PREVOST

WARRANTY BULLETIN

Wb97-30

DATE: December 1997 SECTION:05
SUBJECT: Fuel Cooler Bracket

FIGURE 1

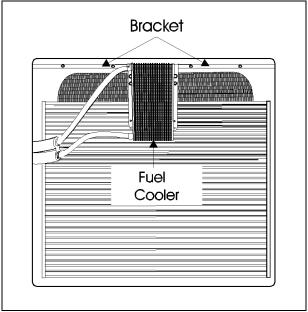
On the above-mentioned vehicle, a stiffer bracket for the fuel cooler must be installed.

Note: For MTH and VIP, order bracket (Prevost #032243). For XL and H3 coaches, order bracket (Prevost #032242).

1. In radiator compartment, unbolt and remove actual bracket.

- 2. Unbolt fuel cooler from bracket.
- 3. Bolt fuel cooler on new bracket then bolt the bracket in radiator compartment.
